RM 02 / 03

Problems and Hints

FIELD CHANGE ORDER

FIELD CHANGE ORDER

SUBJECT: SMD ABSOLUTE FILTER REPLACEMENT DETERMINED BY FILTER-FLOW PRESSURE MEASUREMENT.

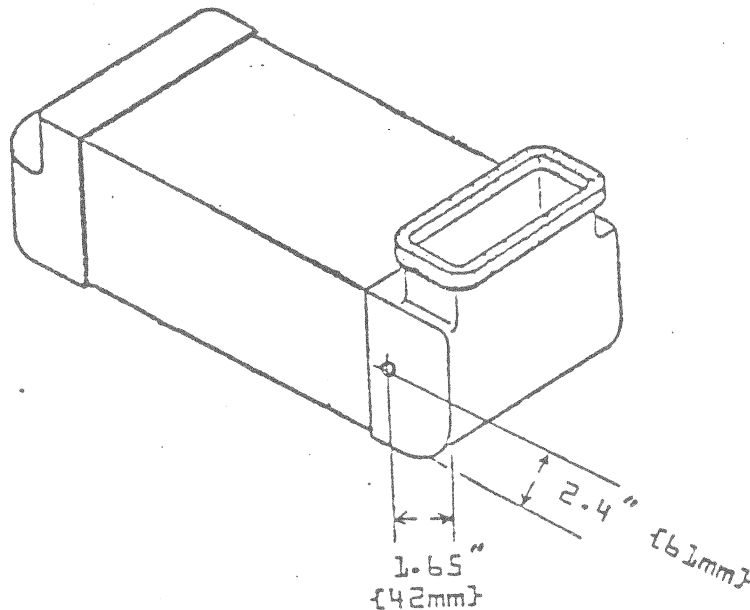
IF ABSOLUTE FILTER DOES NOT HAVE A HOLE AND PLASTIC PLUG INSERTED AT LOCATION SHOWN IN FIGURE BELOW, REMOVE FILTER FROM DRIVE AND DRILL .25 INCH {6.35mm} HOLE. THOROUGHLY CLEAN SHAVINGS FROM FILTER BEFORE INSTALLING BACK INTO DRIVE. PLASTIC PLUG MUST BE INSERTED AT ALL TIMES EXCEPT WHEN TAKING PRESSURE MEASUREMENT.

PROCEDURE: REMOVE POWER FROM DRIVE. INSURE PRIMARY FILTER IS CLEAN AND ALLOWING MAXIMUM AIR FLOW. GAIN ACCESS TO ABSOLUTE FILTER, REMOVE PLASTIC PLUG AND INSERT TUBING ATTACHED TO PRESSURE GAUGE. APPLY POWER TO DRIVE AND LOAD HEADS. IF PRESSURE IS .5 INCH-WATER OR LESS, FILTER SHOULD BE REPLACED. ; IF PRESSURE IS ABOVE .5 INCH-WATER, FILTER NEED NOT BE REPLACED AT THIS TIME. REMOVE TUBING, INSERT PLUG, AND RETURN UNIT TO NORMAL OPERATION.

SPORADIC ± 5 VOLTAGE DRIFT ~~FOR~~ INFORMATION ONLY

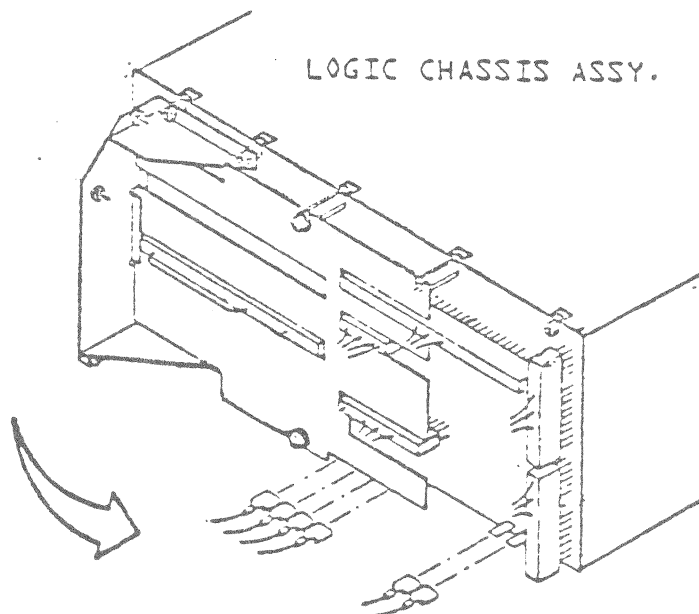
BACKGROUND: FIELD REPORTS OF SPORADIC VOLTAGE FAULTS HAVE BEEN TRACED TO POSSIBLE DETERIORATING CONTACTS OF THE ± 5 VOLT RECEPTACLES AT THE LOGIC CHASSIS. (SEE FIGURE BELOW) SINCE THE FACTORY HAS BEEN UNABLE TO DUPLICATE THE REPORTED PROBLEM, IT IS SUSPECTED THAT AN UNKNOWN COMBINATION OF TEMPERATURE, HUMIDITY AND AIR FLOW, MAY BE HAVING AN ADVERSE AFFECT ON THESE CONTACTS.

SOLUTION: SOLDERING THESE CONNECTIONS HAS BROUGHT POSITIVE RESULTS AT THOSE FIELD SITES ORIGINALLY REPORTING THE PROBLEM.

IF ANY VOLTAGE DRIFT PROBLEMS ARE BEING EXPERIENCED, IT MAY BE ADVANTAGEOUS TO SOLDER THESE SLIDE-ON RECEPTACLES TO THE CONNECTING TABS, ESPECIALLY THE ± 5 AND ± 20 VOLT CONNECTIONS.

ECO NO. M7686-14L006		CONTINUATION SHEET	
SHEET 2 OF 2		DESCRIPTION OF CHANGE/DISPOSITION OF MATERIAL	
ITEM NO.	DOCUMENT/PART NO.	OLD REV	NEW REV
5.	1300388	--	Res. 2K 1/4 W 5A Delete 1 (R52)

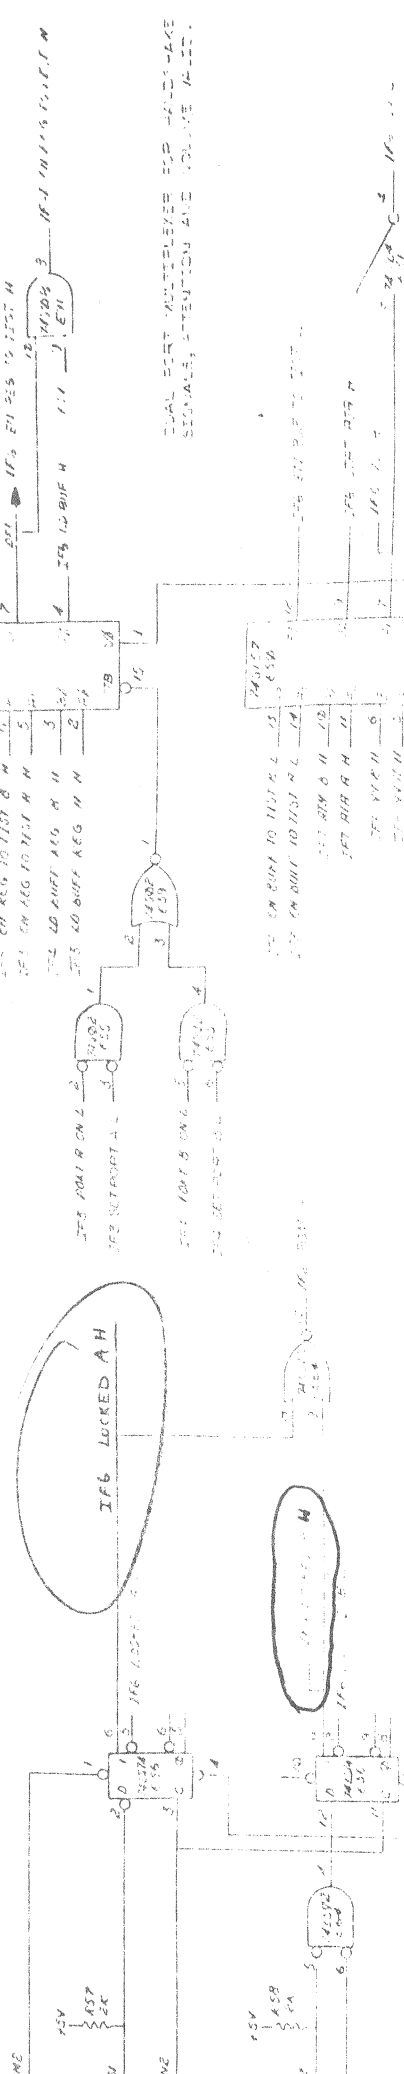
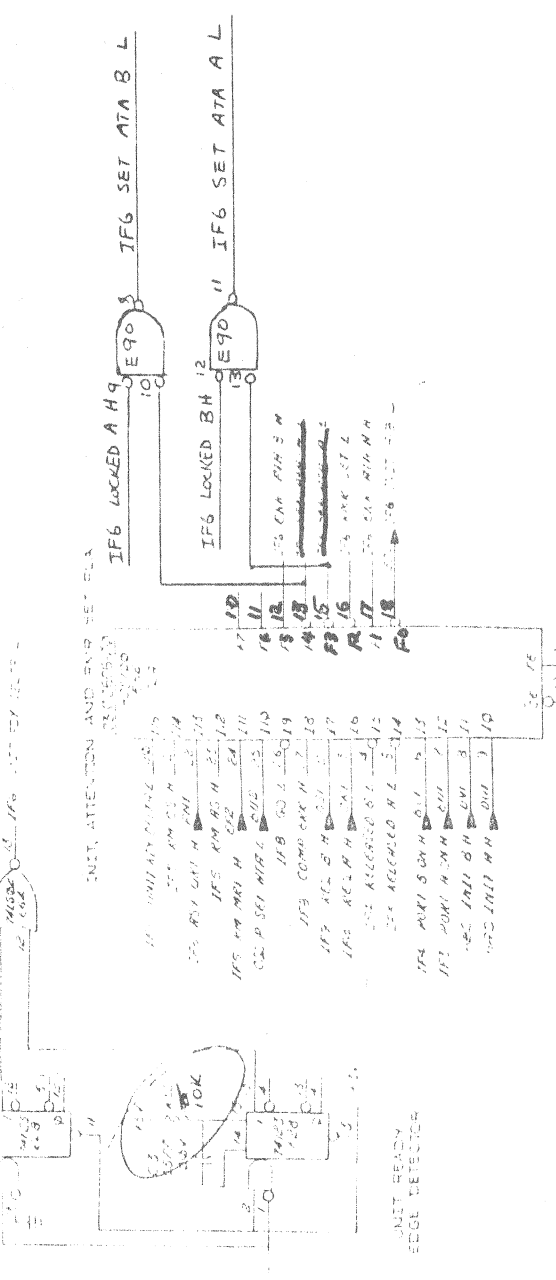
ENGINEERING CHANGE ORDER 1300479		ECO NO. M7686-14L006 SHEET 2 OF 2	
PROBLEM 1. Change in level of unit ready gets attention on Port A and Port B. 2. In dual port configuration software on locked out port re-converges unacceptable attention.			
CORRECTION Rework M7686 logic so that change in level of unit ready causes attention as follows: a. Set ACA A if not locked to Port B and b. Set ACA B if not locked to Port A. See rework instructions for details.			
BREAKING EFFECTIVITY Phase 10, 11, 12, 13, 14, 15, 16, 17, 18, 19, 20, 21, 22, 23, 24, 25, 26, 27, 28, 29, 30, 31, 32, 33, 34, 35, 36, 37, 38, 39, 40, 41, 42, 43, 44, 45, 46, 47, 48, 49, 50, 51, 52, 53, 54, 55, 56, 57, 58, 59, 60, 61, 62, 63, 64, 65, 66, 67, 68, 69, 70, 71, 72, 73, 74, 75, 76, 77, 78, 79, 80, 81, 82, 83, 84, 85, 86, 87, 88, 89, 90, 91, 92, 93, 94, 95, 96, 97, 98, 99, 100			
GUIDE CHANGES R52 WILL BE 10K			
LIST 1. F-DD-M7686-0 2. D-CB-M7686-0-1 3. E-PI-M7686-0-2 4. E-DA-M7686-0-0

6.	1300447	--	Res. 4.7K 1/4 W 5A Delete 1 (R60)
7.	1300479	--	Res. 10K 1/4 W 5A Add 2 (R52, R60)
REWORK INSTRUCTIONS FOR M7686			
REV B ETCH			
<ol style="list-style-type: none"> Remove wire from E69-3 to E62-13 Remove wire from E91-1 and insert wire into E90-13 Add a wire from E90-11 to E91-1 Add a wire from E90-12 to E64-9 Add a wire from E90-8 to E69-3 Add a wire from E90-9 to E64-8 Add a wire from E90-10 to E62-13 Change R52 from A 2K Res. to A 10K Res. Change R60 from A 4.7K Res. to A 10K Res. 			
REV C ETCH			
<ol style="list-style-type: none"> Cut etch on Side 2 from E91-1 to feedthru Cut etch on Side 1 from E69-3 to feedthru Add a wire from E90-11 to E91-1 Add a wire from E90-12 to E64-9 Add a wire from E90-13 to feedthru between filter cap. and E91-1 Add a wire from E90-8 to E69-3 Add a wire from E90-9 to E64-8 Add a wire from E90-10 to feedthru below E69-4 Change R52 from A 2K Res. to A 10K Res. Change R60 from A 4.7K Res. to A 10K Res.
